# APPENDIX E – Construction Traffic and Pedestrian Management Plan

## Preliminary Construction Traffic and Pedestrian Management Sub-Plan

<b>Project name</b>	New High in Jerrabomberra						
<b>Document title</b>	New High School in Jerrabomberra   Preliminary Construction Traffic and Pedestrian Management Sub-Plan						
<b>Project number</b>	12548316						
<b>File name</b>	12548316 Jerrabomberra CTPMSP Rev A.docx						
Status Code	Revision	Author	Reviewer		Approved for issue		
			Name	Signature	Name	Signature	Date
S3	A	M Lucas	Jayme Akstein	On file	J Deng	On file	11/07/22
S4	1	M Lucas	Jayme Akstein	On file	J Deng	On file	11/07/22
S4	2	M Lucas	Jayme Akstein	On file	Jayme Akstein	On file	04/08/22

**Subject:** JHS: SSD Condition B14 - CTPMSP

Sat image showing completed bus lane

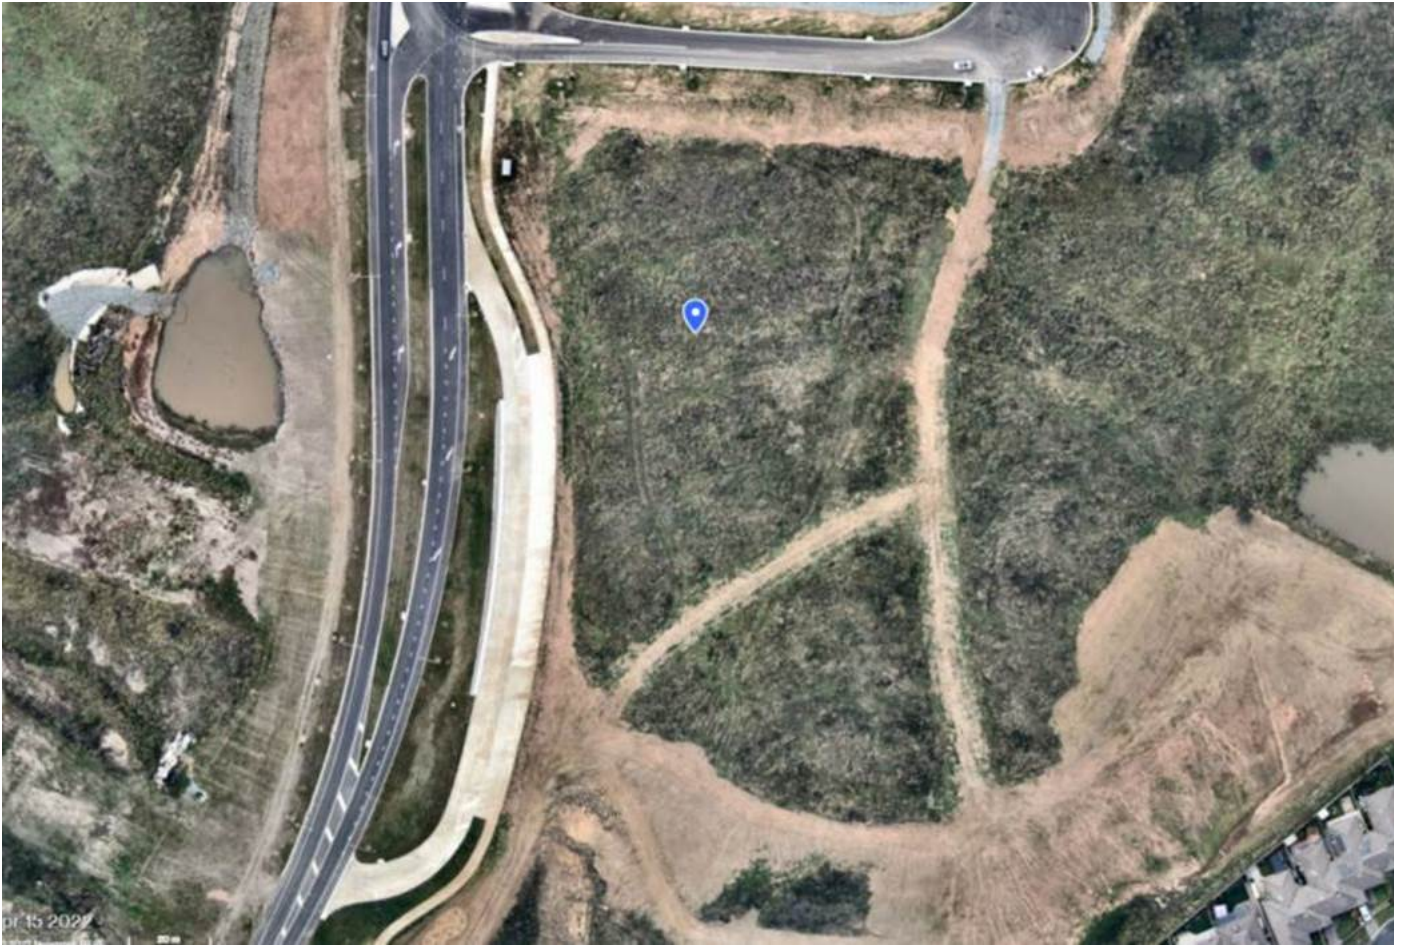
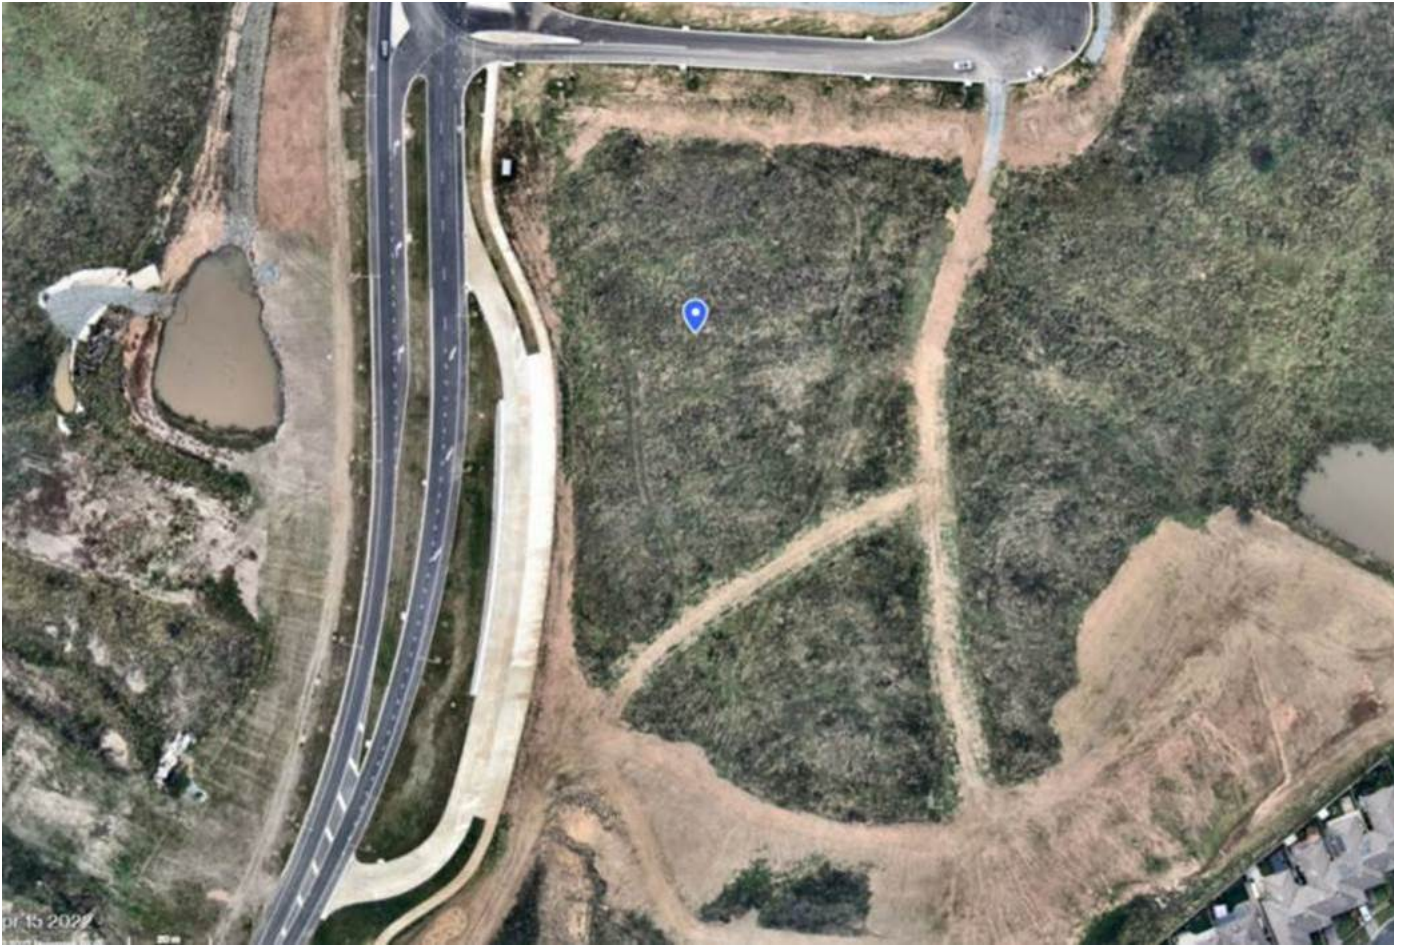
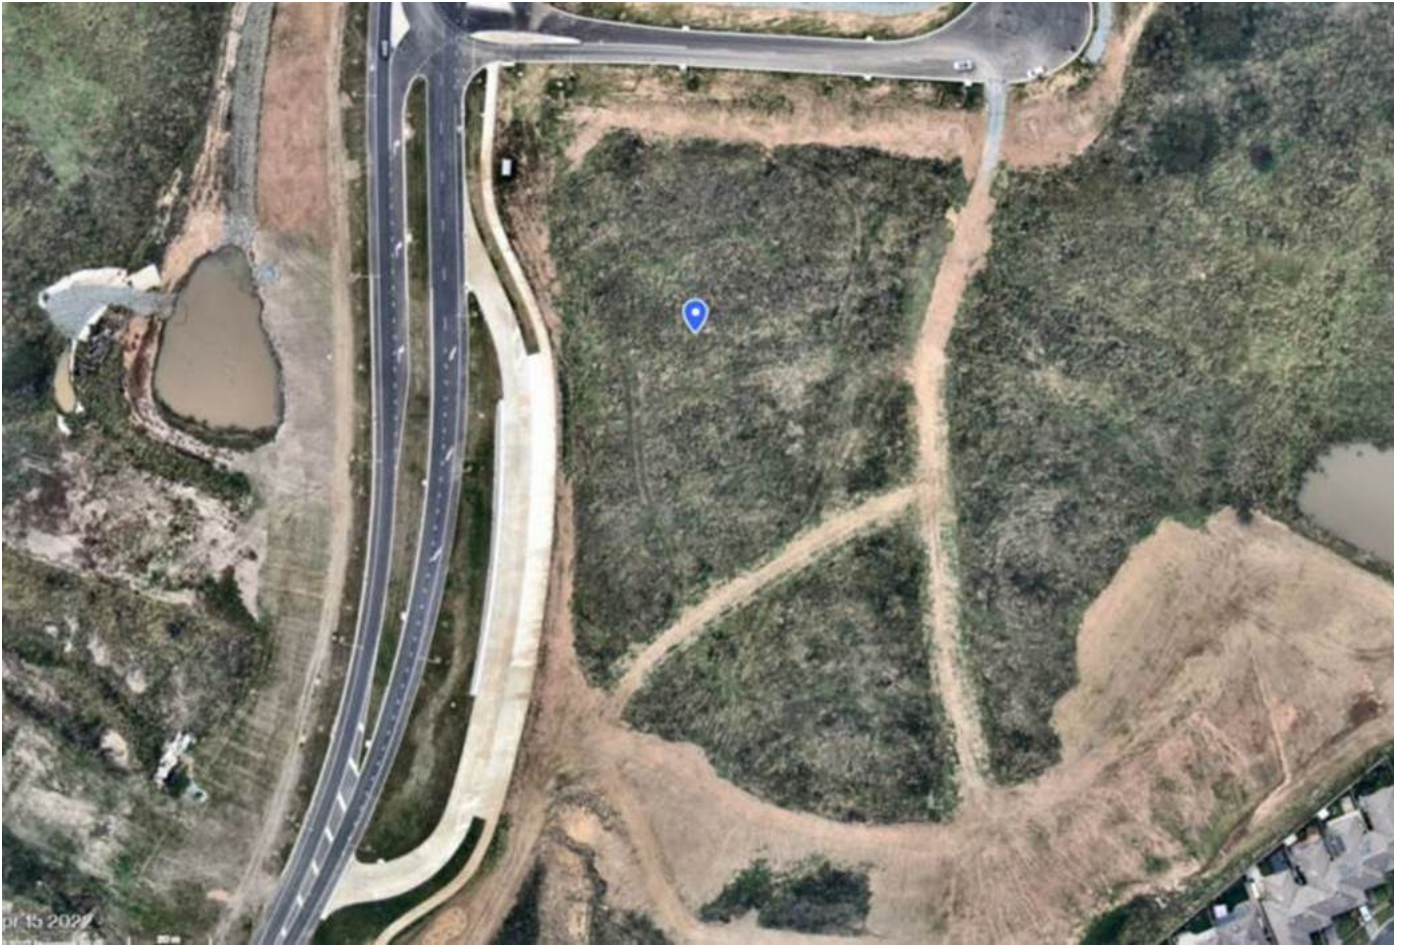
1. If gate 2 is to be closed then there needs to be enough storage for the appropriate Heavy Vehicle
2. FOOTPATH CLOSED use other footpath should probably read FOOTPATH CLOSED follow detour
  - a. Where is the pedestrian detour ?
  - b. Noting the length of the closure, It needs to be on a concrete path built to disability access requirements
3. Need notes regarding exit from bus bay as left only
4. Move the end roadworks sign until after your Heavy Vehicles finish joining
5. Remove note (signs to be placed if southbound road open for traffic) – road is open all the time

In addition to comments below, please see evidence of changes below:  
[Site establishment plan.](#)
